CITY PLAN COMMISSION REPORT

Tru by Hilton

14 CD-CPC-2022-00005
Rezoning to UR/MPD

Plan Conditions, Corrections, & Recommendations Report

FIRE PROTECTION
PLAN

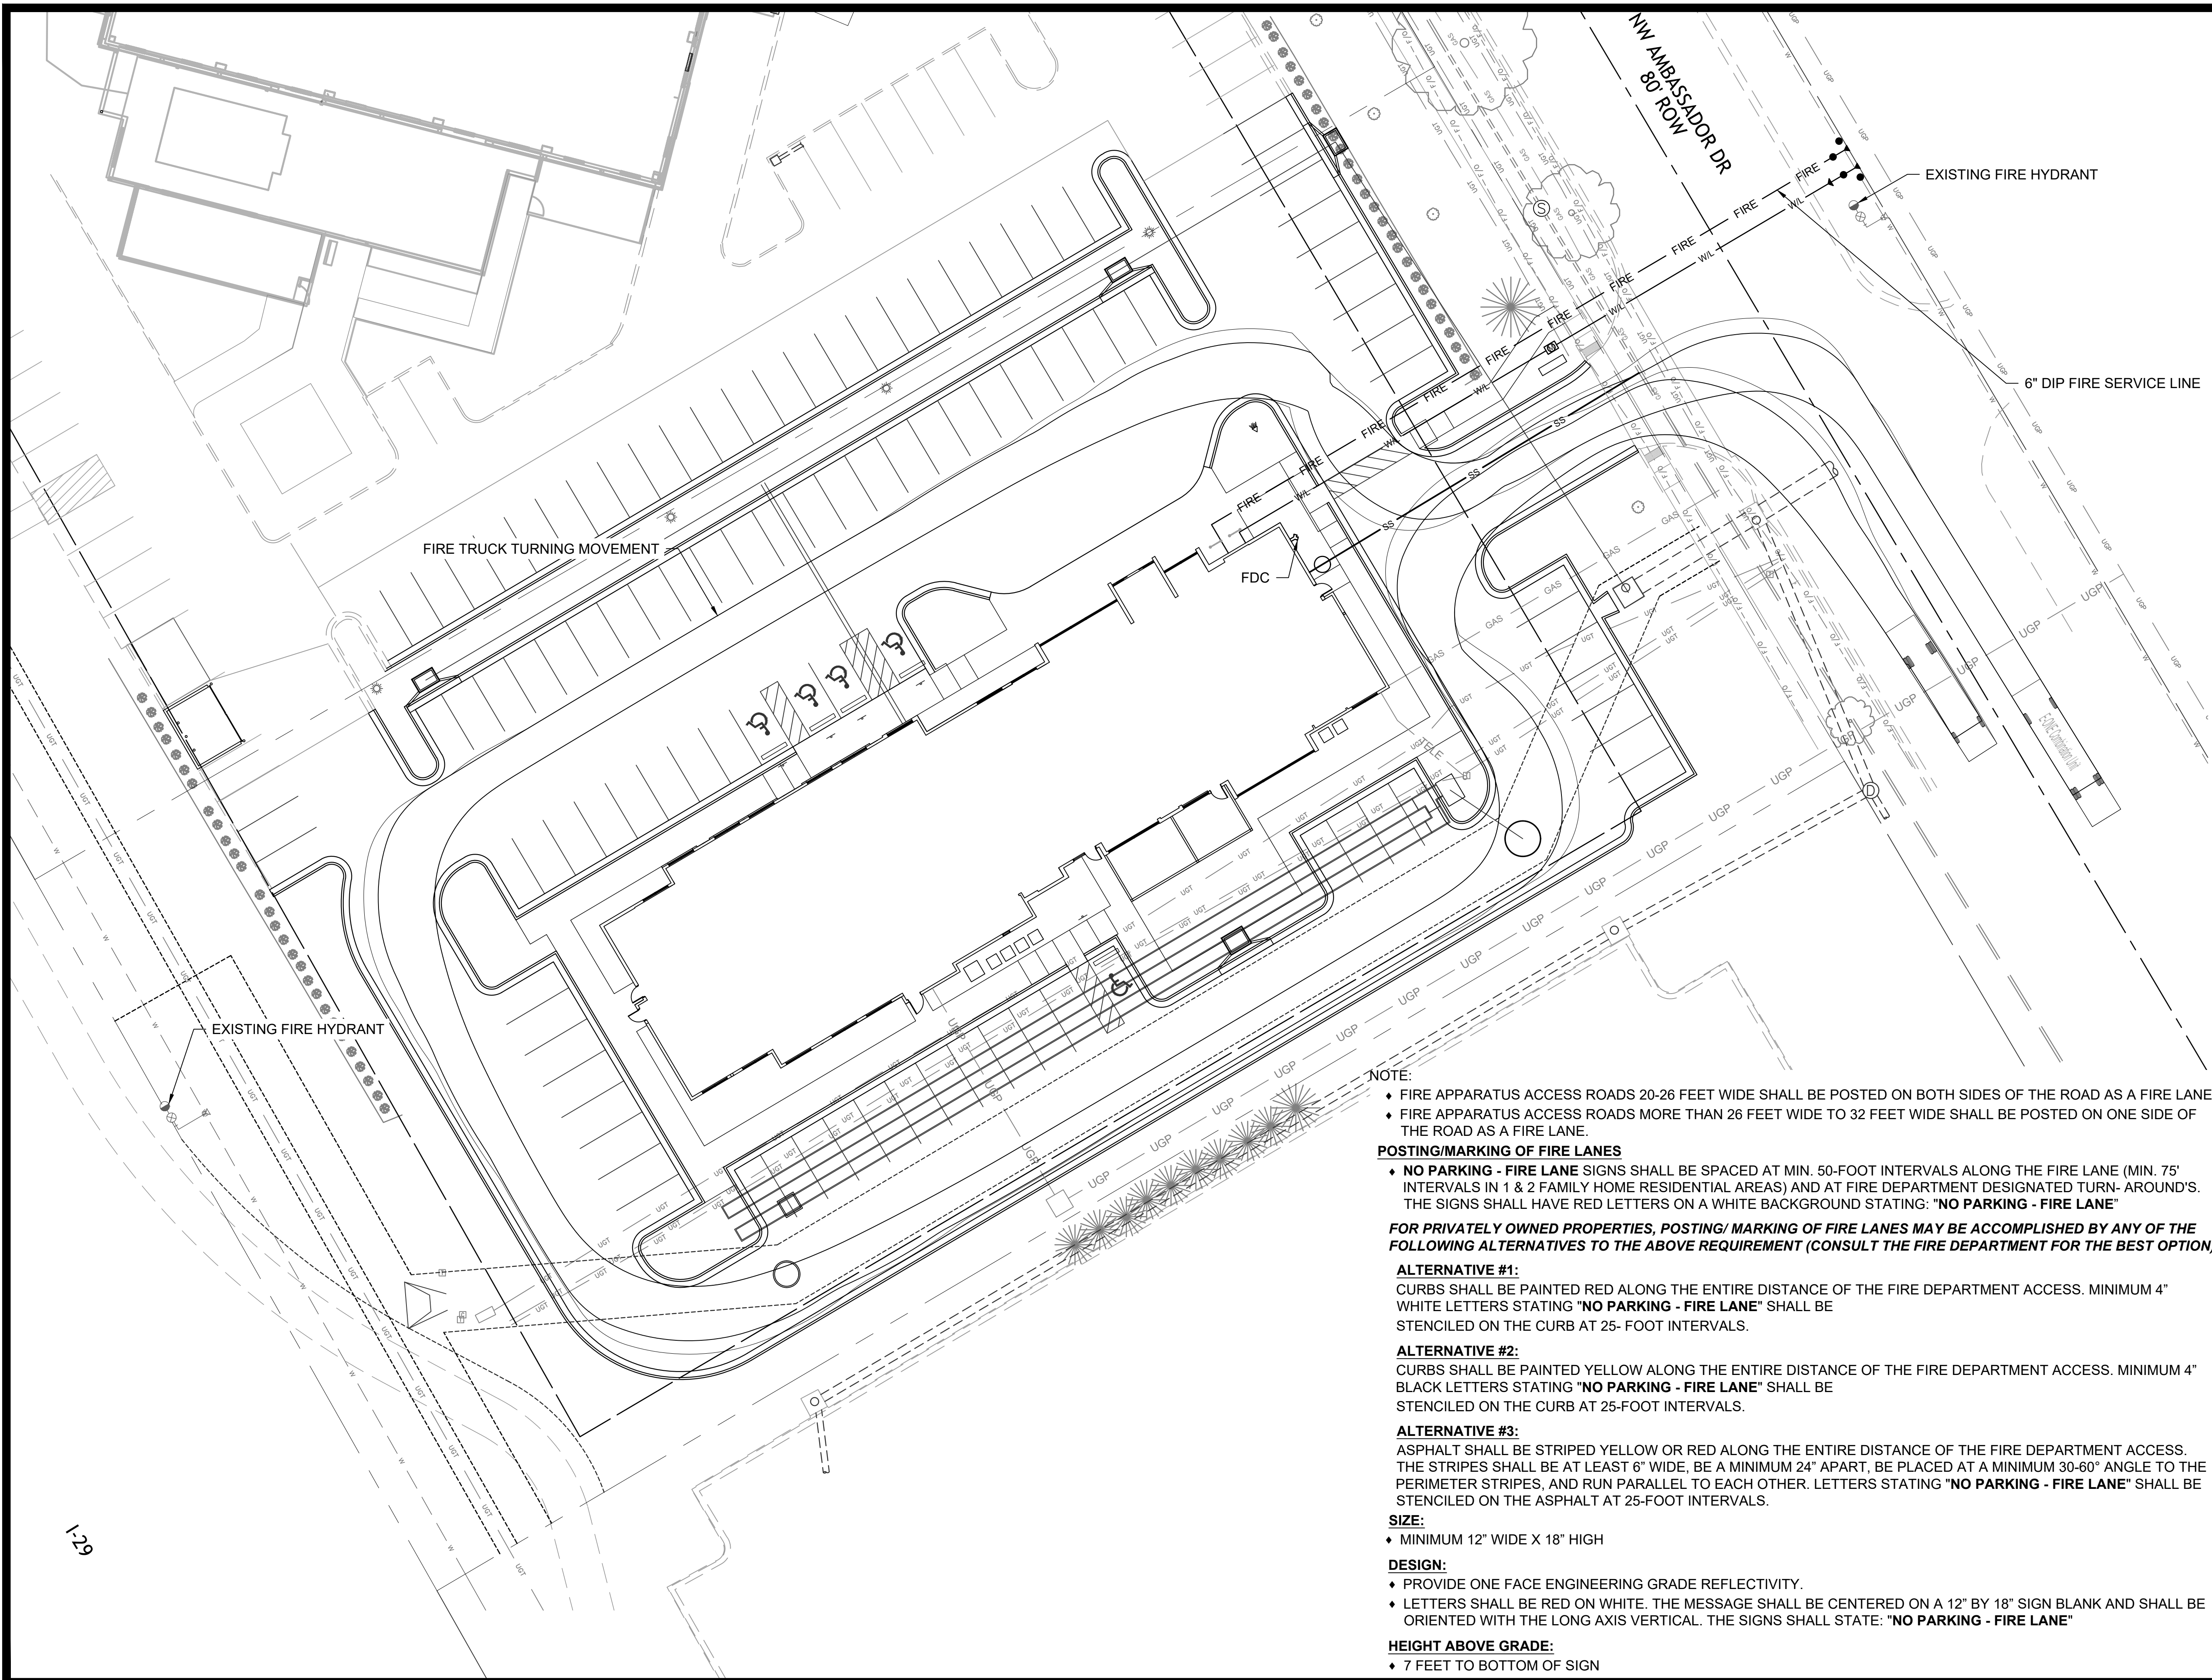
13. Fire Water Flow The project shall meet the fire flow requirements as set forth in Appendix B of the International Fire Code 2018. (IFC-2018 § 507.1) (1/26/2022)

14. Fire Department Connection Buildings equipped with a fire standpipe system shall have an operable fire hydrant within 100 feet of the Fire Department Connection (FDC). (IFC2018 § 507.5.1.1) (1/26/2022)

15. Hydrant Fire hydrant distribution shall follow IFC-2018 Table C102.1
Fire hydrants shall be installed and operable prior to the arrival of any combustible building materials onto the site. (IFC-2018 § 501.4 and 3312.1; NFPA -2013 § 8.7.2) (1/26/2022)

16. Fire Department Access The turning radius for fire department access roads is 30 feet inside and 50 feet outside radius. (IFC-2018: § 503.2.4) (1/26/2022)

17. Fire Department Access Aerial Fire Apparatus access roads shall be provided for any building that is 30 feet in height or greater. Aerial Fire Apparatus Roads are a minimum 26 feet wide, at least 15 feet away from the building but not more than 30 feet from the structure. (IFC-2018 § D105). (1/26/2022)

1 SIGNAGE PLAN- MONUMENT SIGN
SCALE 1" = 20'-0"

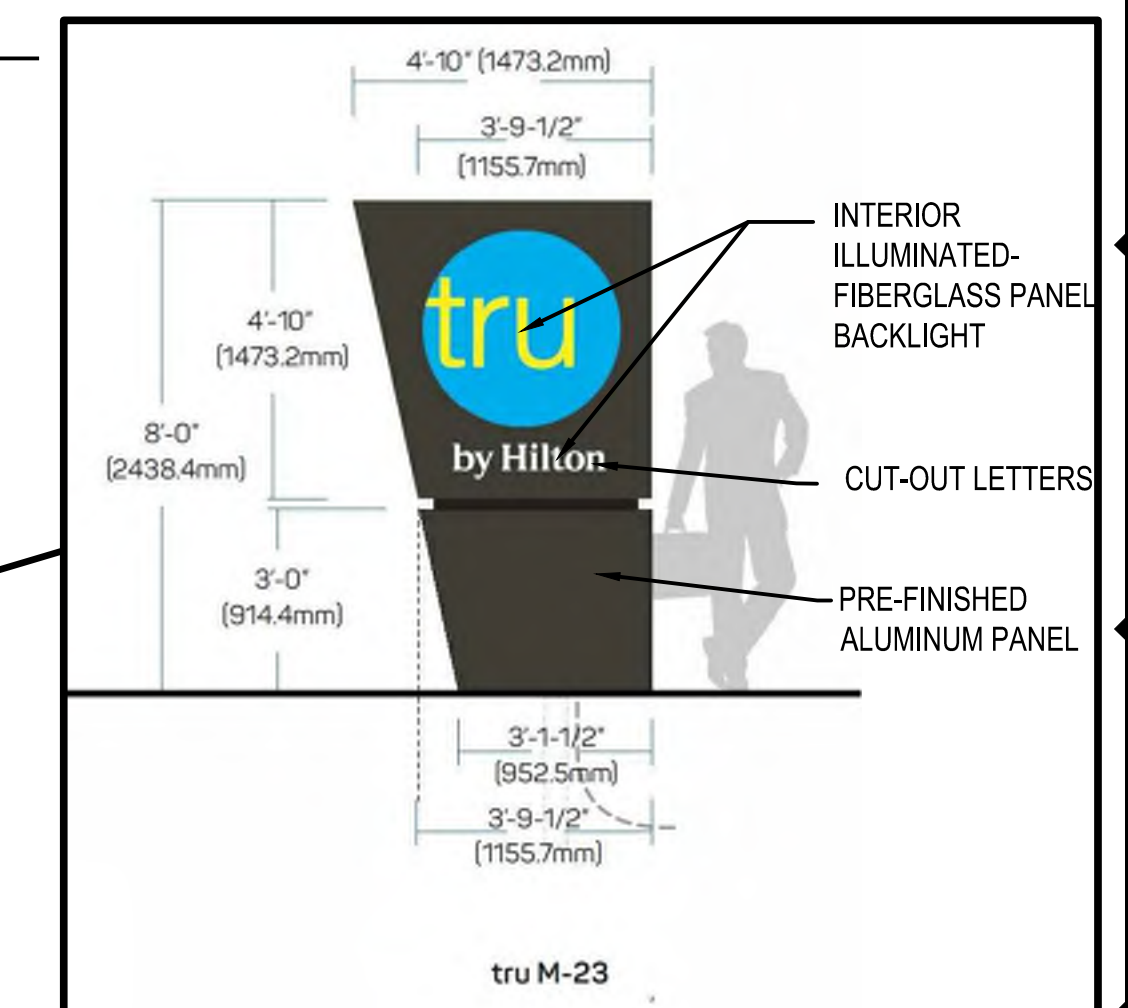
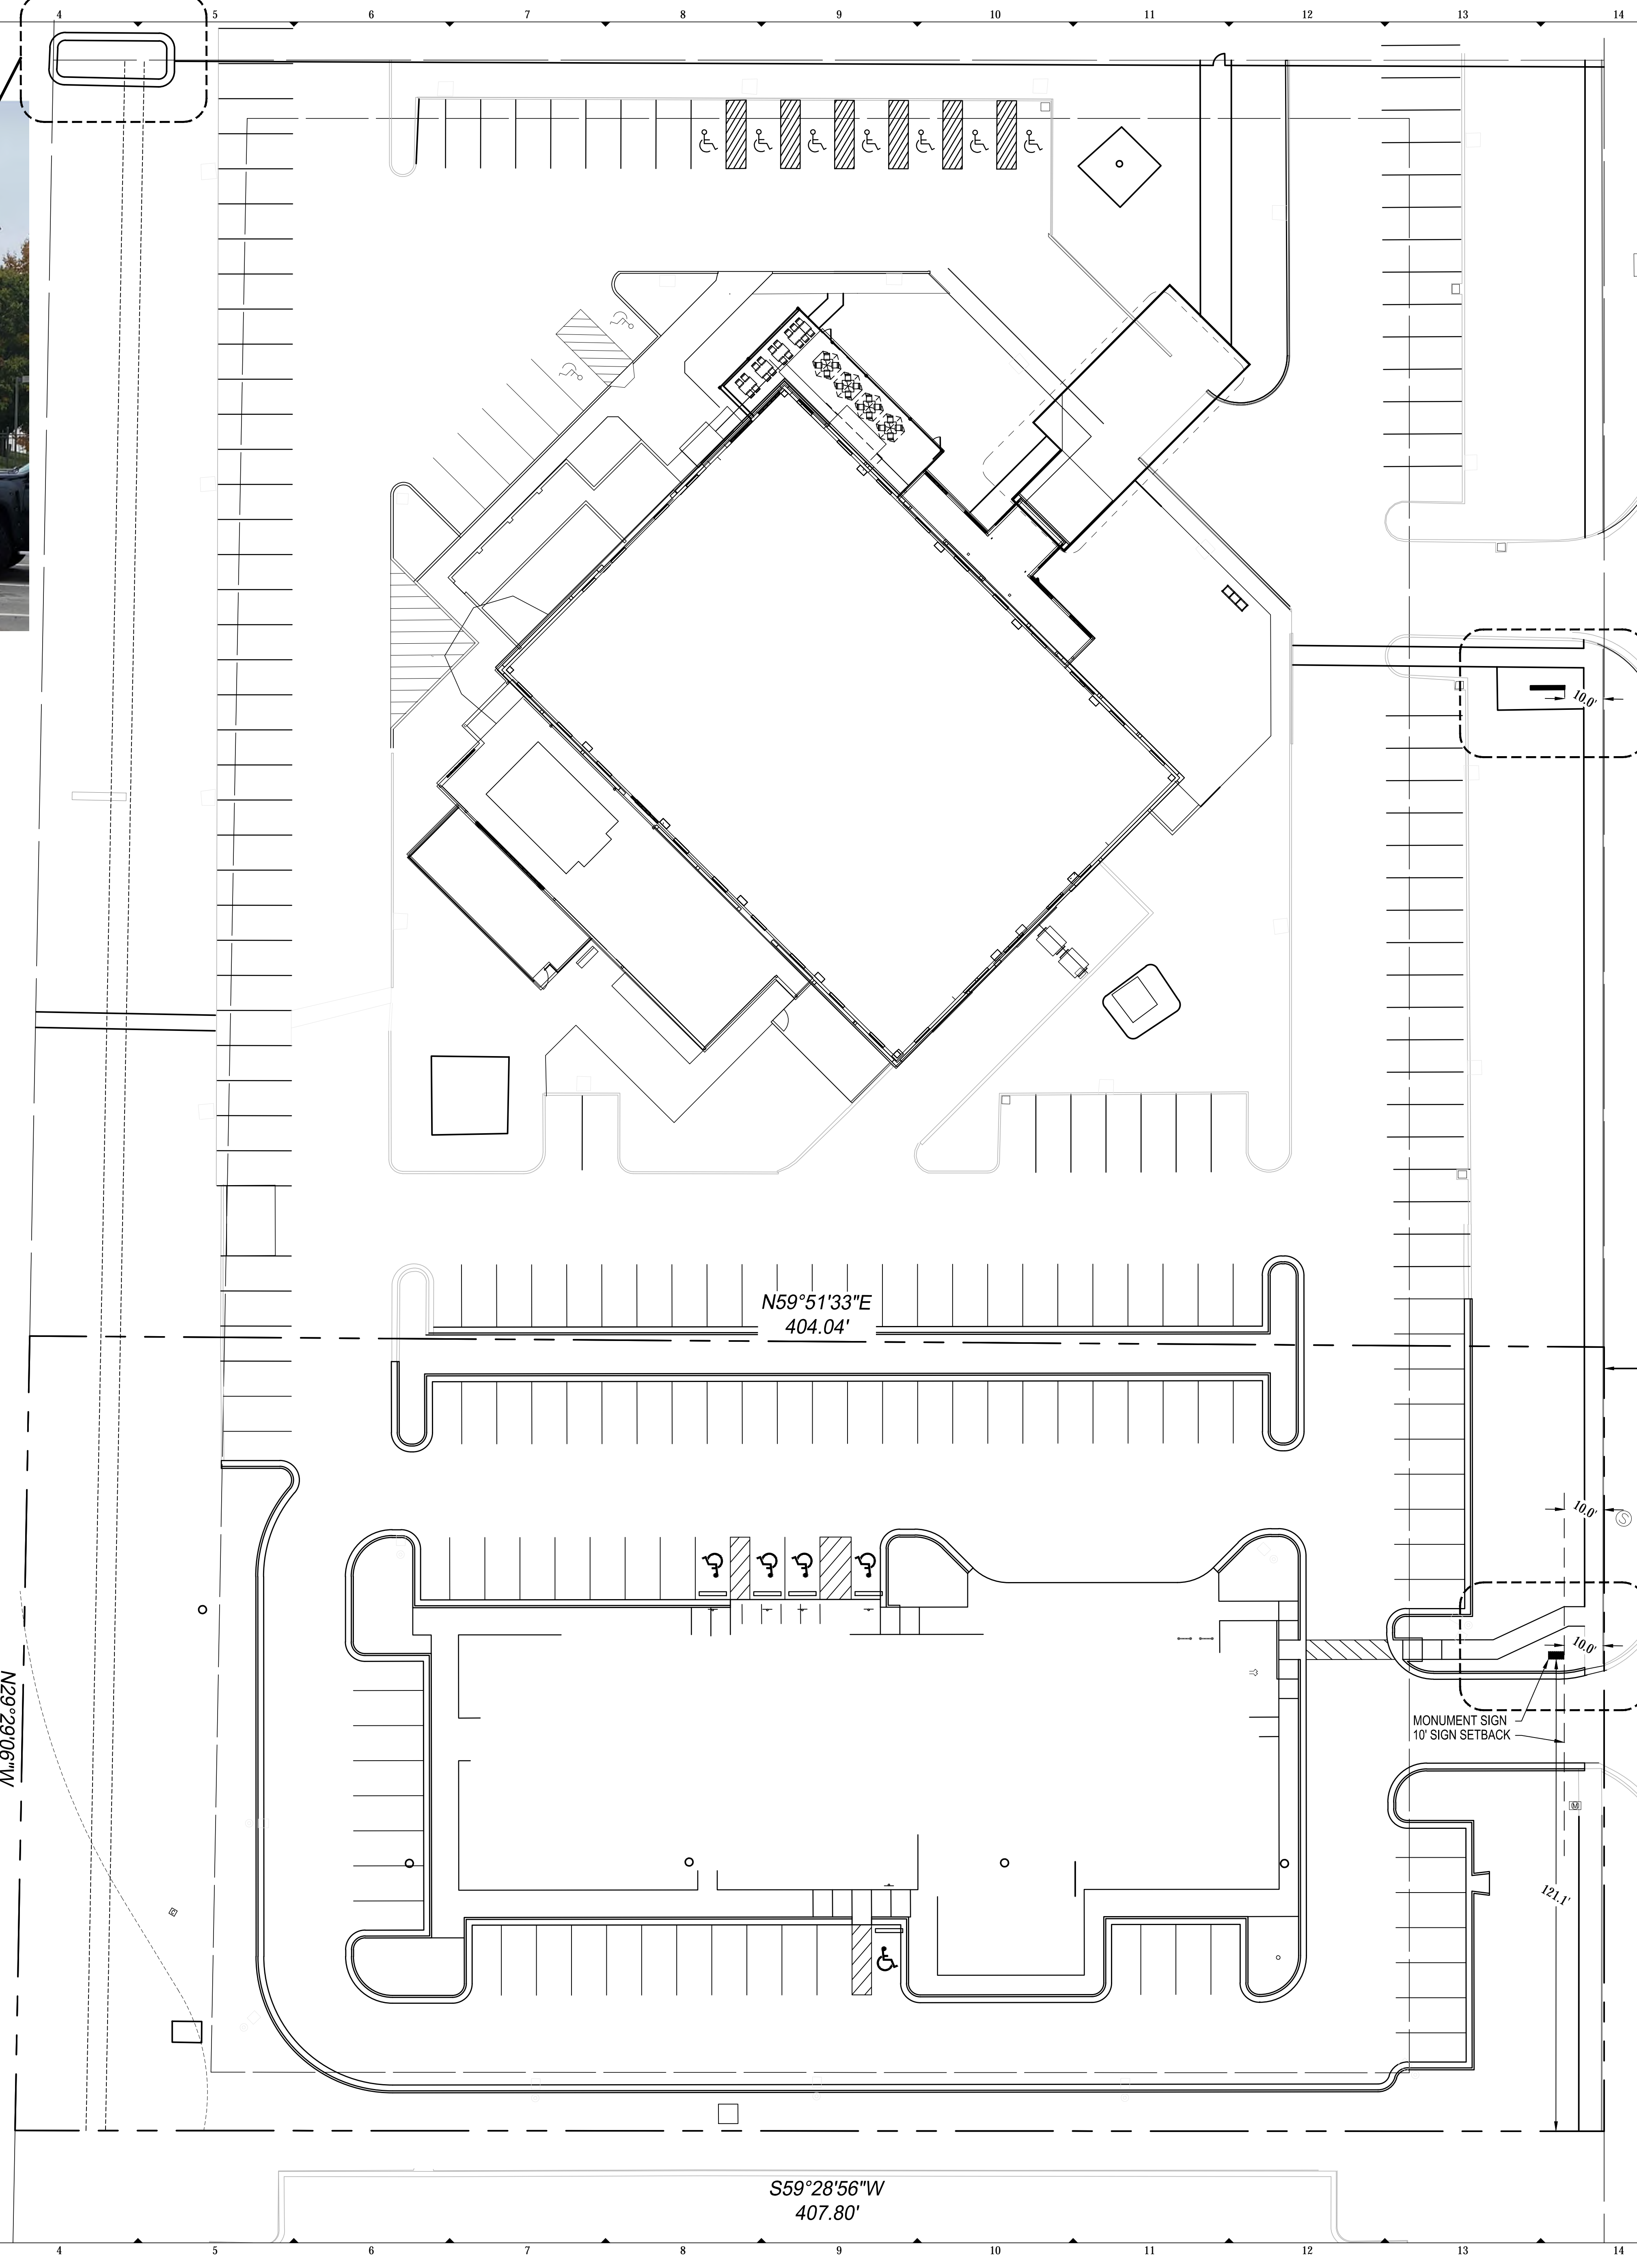
12. Reduce the proposed monument sign to 6' or add landscape around the entire base with a minimum 3' height after the first growing season. (2/16/2022)
